V2500 Propulsion System — Nacelle

NACELLE - POWERPLANT - COWL, AIR INTAKE - ADAPTER RING ATTACHING RIVETS -  
INSPECTION/REPLACEMENT OF

June 3, 1999

**V2500-NAC-71-0186**

INSPECTION/REPLACEMENT OF AIR INTAKE COWL RIVETS  
FIGURE 1

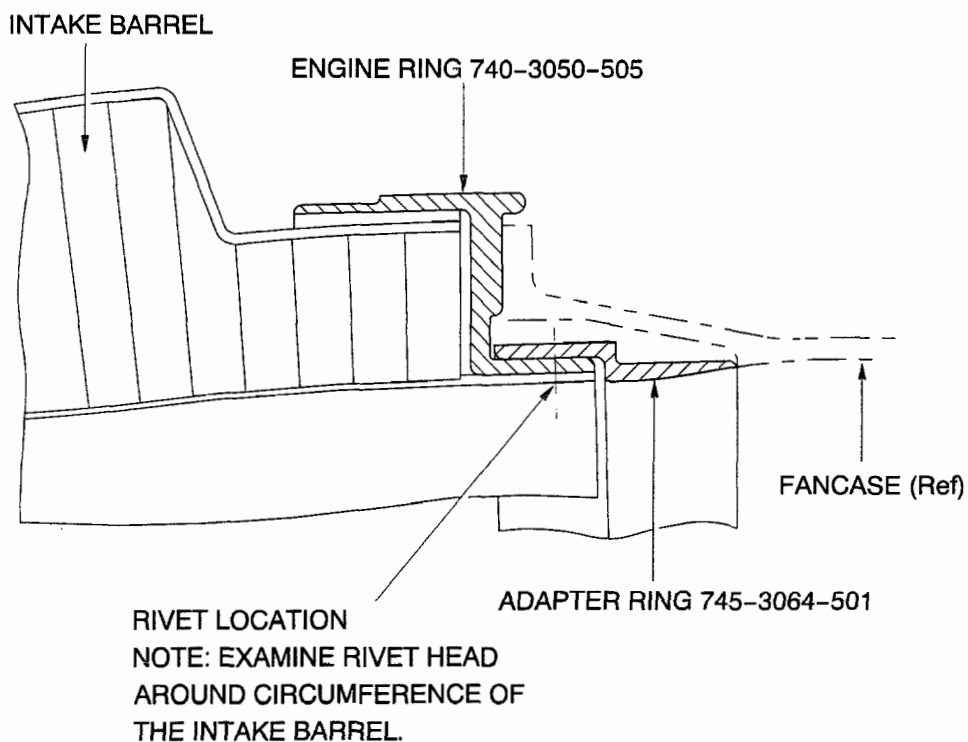
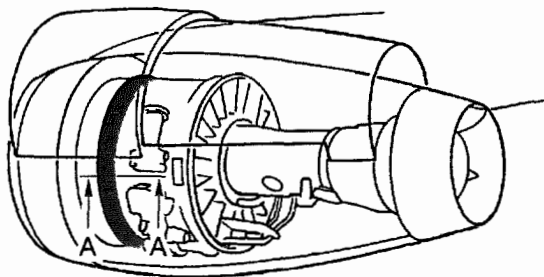
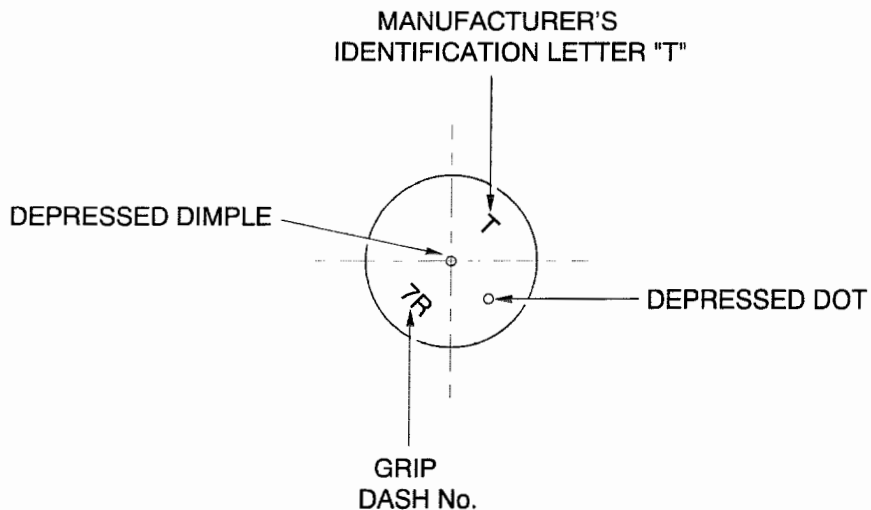
- (2) Clean the Adapter ring on the Air Intake Cowl with a clean lint-free cloth(CoMat 02-099)made moist with solvent (COMAT 01-076) or (COMAT 01-457). Wipe the area dry before the solvent evaporates.
- (3) Examine the Adapter ring assembly for CSR922-6-7R rivets as shown. Refer to Figures 1 and 2. Proceed with Step 2.B.(4) if any CSR922-6-7R rivets are found, otherwise proceed to Paragraph 2.C.

RIVET LOCATION  
NOTE: EXAMINE RIVET HEAD  
AROUND CIRCUMFERENCE OF  
THE INTAKE BARREL.

- (4) Replace the CSR922-6-7R rivets with CSR902B6-10 rivets as follows:
  - (a) Carefully drill out the CSR922-6-7R rivets making sure you do not elongate the holes. Do not remove more than ten rivets at one time.
  - (b) Measure the rivet holes to ensure they are between 0,191 in.(4,85mm) and 0,195 in.(4,95mm) diameter.
  - (c) Install the CSR902B6-10 rivets in place of the CSR922-6-7R rivets. Refer to the IAE V2500 Standard Practices/Processes Manual(SPP-V2500-11A)Chapter/Section 70-39-03,Installation of rivets.
  - (d) Remove any unwanted material and metal particles from the Air Intake Cowl.
  - (e) Do steps 4(a) thru 4(d) until all the CSR922-6-7R rivets are replaced.

RIVET IDENTIFICATION MARKINGS  
FIGURE 2

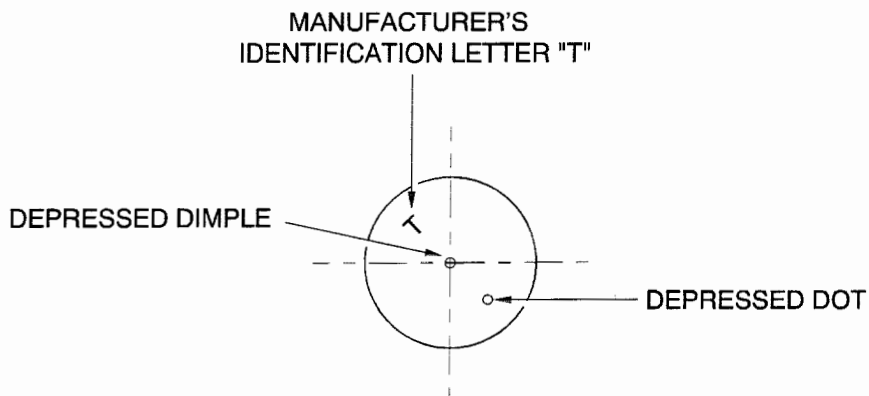
- (a) The Engine Adapter Ring is inspected for Cherry CSR922-6-7R rivets. These rivets are drilled out and new Cherry CSR902B6-10 E-Z rivets installed.

MARKINGS FOR CHERRY BUCK RIVET CSR922-6-7R (CSK HEAD)

MARKINGS FOR CHERRY E-Z BUCK RIVET CSR902B6-10 (CSK HEAD)
